ADDENDUM NUMBER 1

DATE: March 6st, 2024

PROJECT: St. Clair County DTNW – Facility Renovation

PROJECT NUMBER: 0230-0002

PARTIAL SECOND FLOOR PLAN
 1/8" = 1'-0"

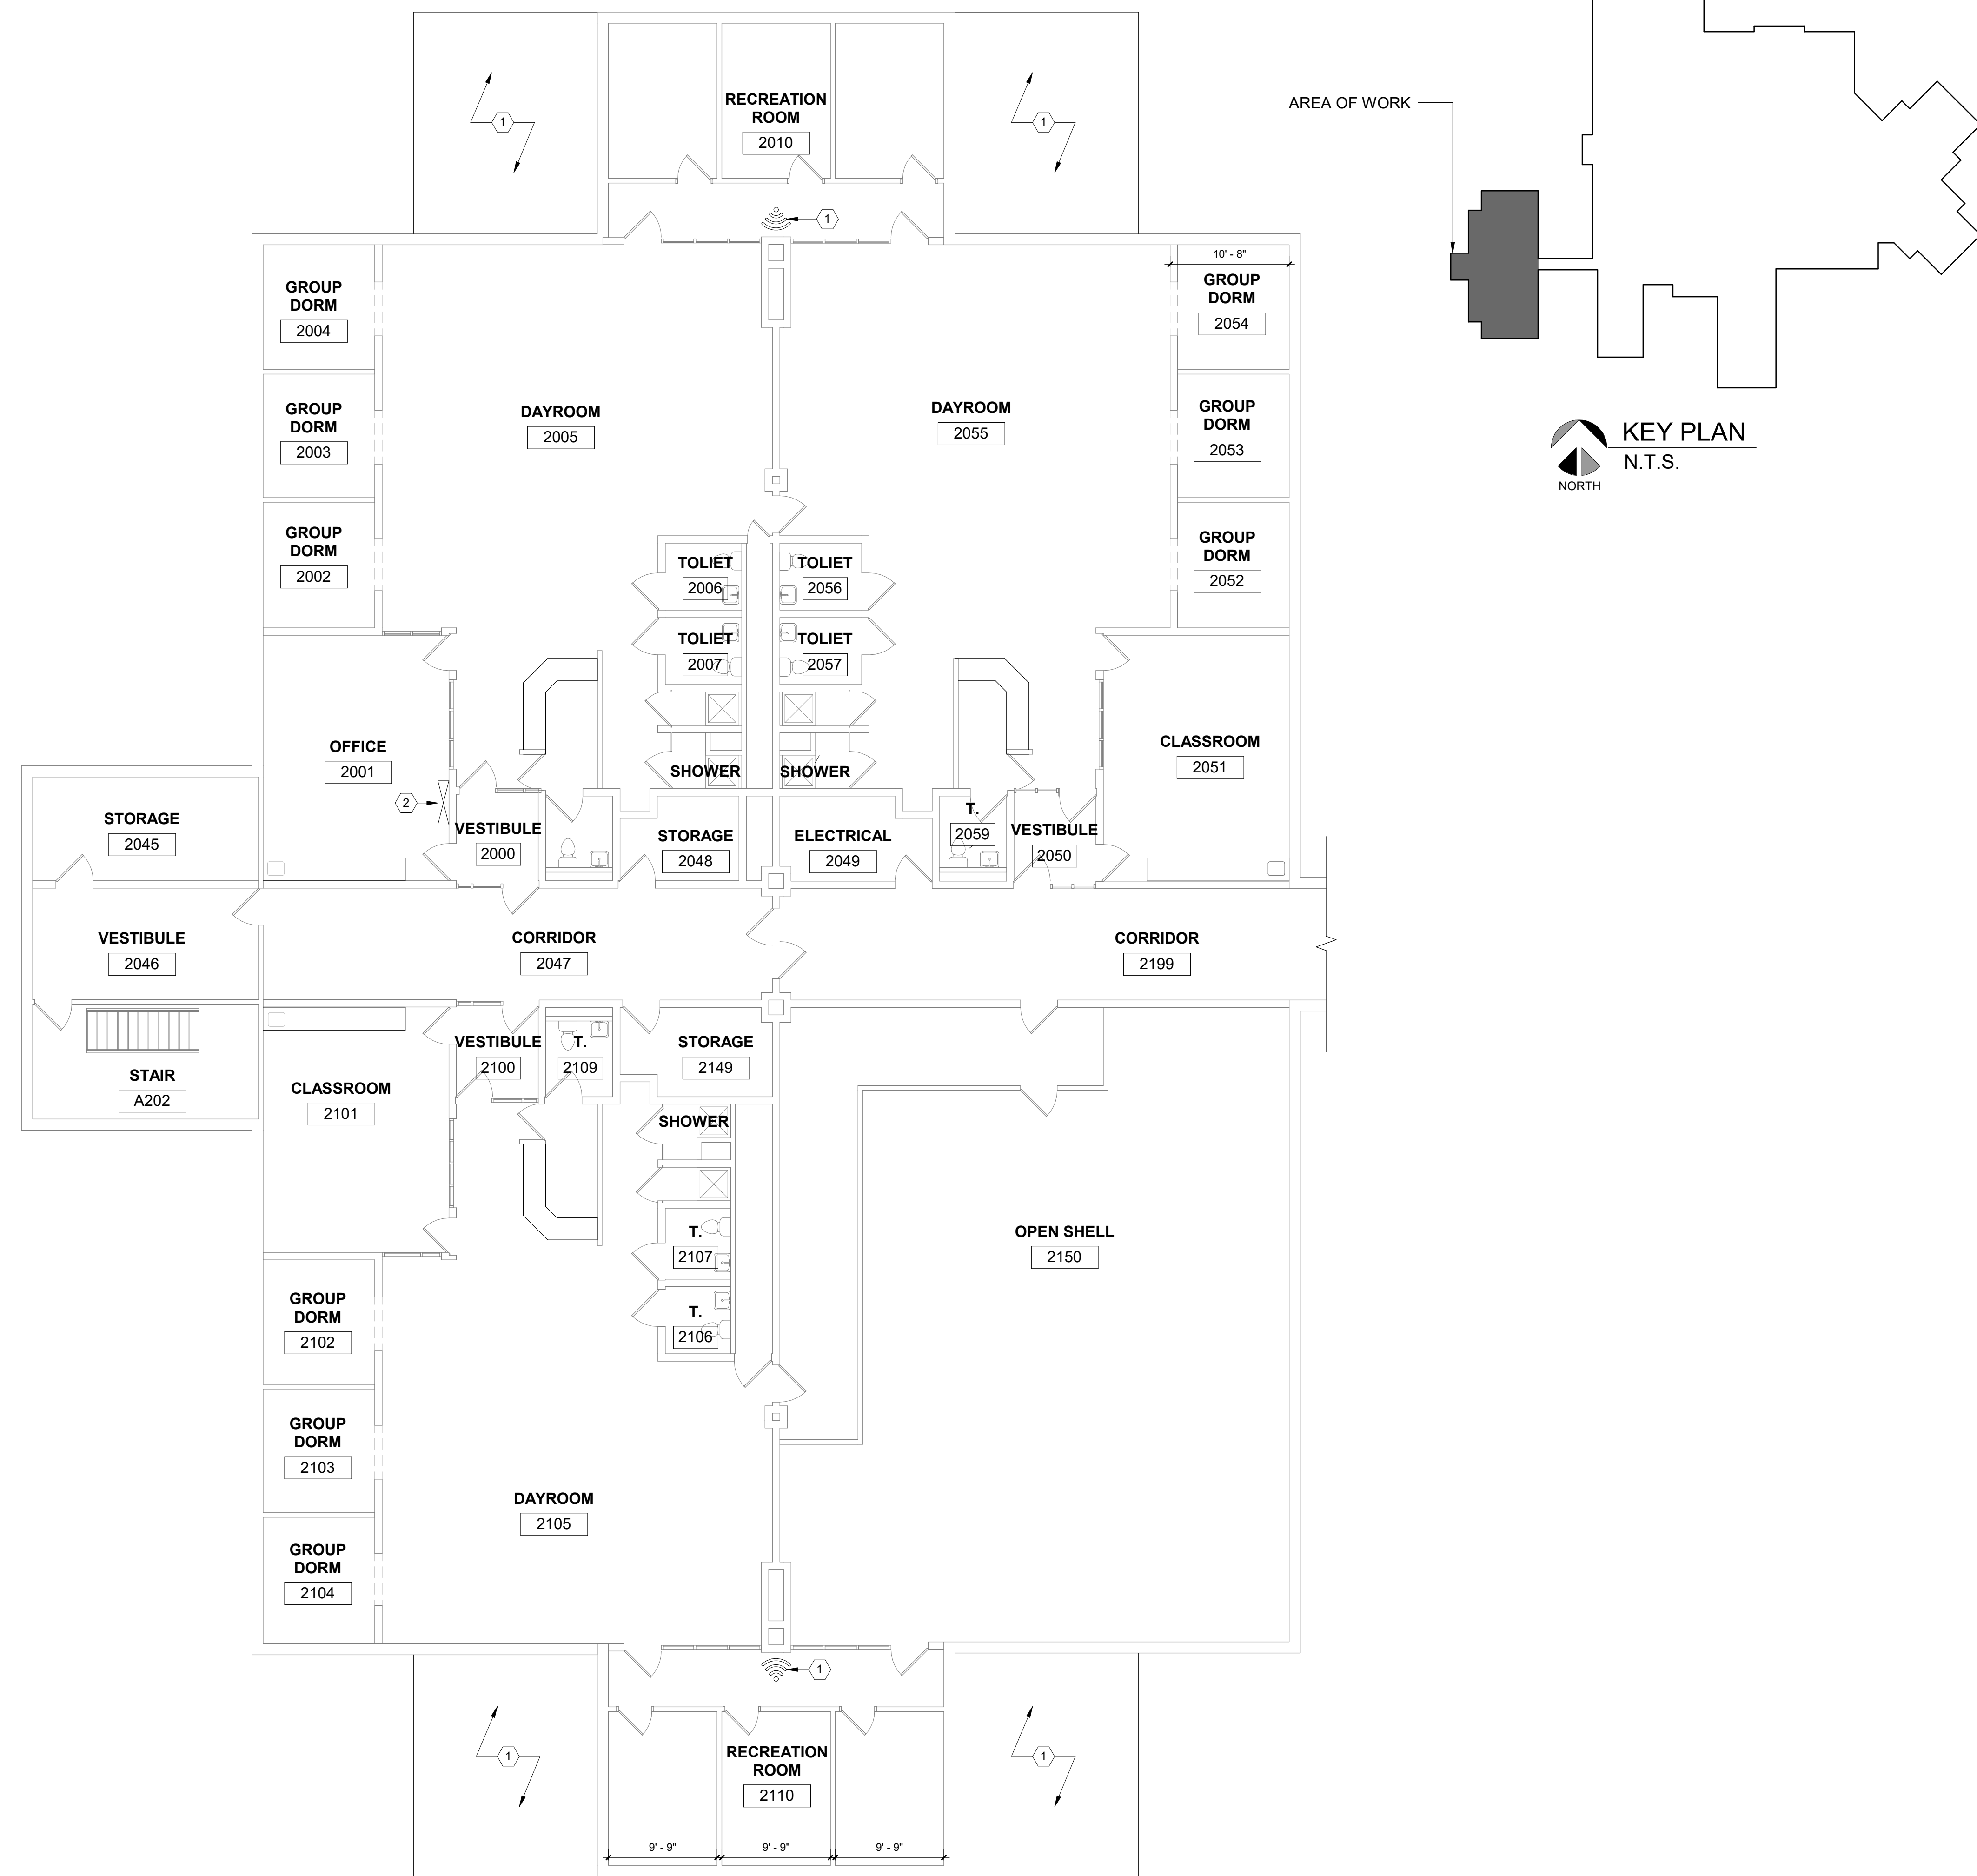
Q: Drawing A-102 Note #1 indicates New Wireless Access Router. Please advise if this is being provided by the owner, if not please provide specifications.

Q: Drawing A-102- Note #2 indicates CCTV View Station. Please advise if this is being provided by the owner, if not please provide specification.

2. SHEET A031:
 - a. Updated Spec.
3. SHEET A102:
 - a. Updated Floor Plan Keynotes.
4. SHEET A401:
 - a. Updated Keynotes and Reflected Ceiling Plan.
5. SHEET A403:
 - a. Updated Detail #5.

A: By owners' vendor, Conti

A: By owners' vendor, Conti
